UNITED STATES PATENT AND TRADEMARK OFFICE

10/622,491

Office Action Summary

DETAILED ACTION

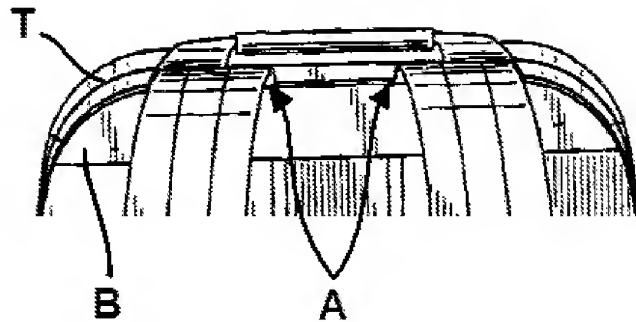
Regarding claims 38, 42, 44, 48, the back-facing face of the modified Ivarson et al. backpack has a top end (T, figure below) and the shoulder strap is connected to the back-facing face (B, figure below) at a position (A, below) spaced from the top end of the back-facing face.
